Access Compliance Report

Public Rights-of-Way

(Curb Ramps)

Intersection ID: 32254	Main Street: BALLANTYNE_CROSSING_AV	Cross Street: BALLANTYNE_GLEN_WY	Location: SW
ADA ID: 04B01478C95D	Ramp Type: PerpDiag	Initial Pass/Fail: Fail	Overall Compliance: No
Severity Score: 12.5			
Codes/Mitigation Info/Possible Solution		Field Measurements/Component Compliance

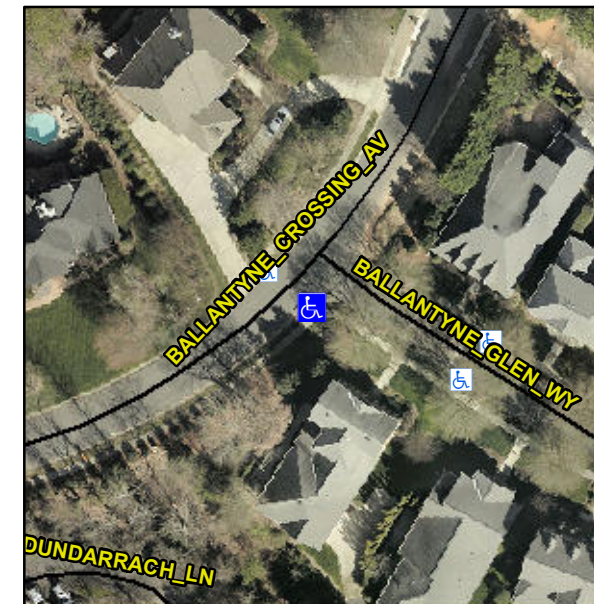
Not Found, R304.2.2

Compliance	Description	Data	Compliance	Description	Data
N/A	Ramp Length (in)	48.0	No	Ramp Slope (%)	8.6
Yes	Ramp Width (in)	48.0	Yes	Ramp XSlope (%)	0.6
N/A	Flare Type LT	N/A	N/A	Flare Type RT	N/A
N/A	Flare Slope LT (%)	N/A	N/A	Flare Slope RT (%)	N/A
N/A	Flare Traversable LT?	N/A	N/A	Flare Traversable RT?	N/A
N/A	Landing Length (in)	N/A	N/A	DWS Provided?	N/A
N/A	Landing Width (in)	N/A	N/A	DWS Contrast?	N/A
N/A	Landing Slope (%)	N/A	N/A	DWS Length (in)	N/A
N/A	Landing X Slope (%)	N/A	N/A	DWS Full Width?	N/A
N/A	Landing Curb? (Y/N)	N/A	N/A	DWS Offset (in)	N/A
N/A	Shared Landing?	N/A			
N/A	Gutter Ponding?	N/A	N/A	Gutter Slope (%)	N/A
N/A	Gutter Lip Ht (in)	N/A	N/A	Gutter X Slope (%)	N/A
N/A	Painted X Walk1?	No	N/A	Painted X Walk2?	No
	X Walk 1 Direction	To NE		X Walk 2 Direction	To NW
N/A	X Walk 1 Width (in)	N/A	N/A	X Walk 2 Width (in)	N/A
	X Walk 1 Slope (%)	3.3		X Walk 2 Slope (%)	4.6
	X Walk 1 X Slope (%)	3.0		X Walk 2 X Slope (%)	2.5

Remove & Replace Curb Ramp With Two New Directional Ramps or Equivalent.
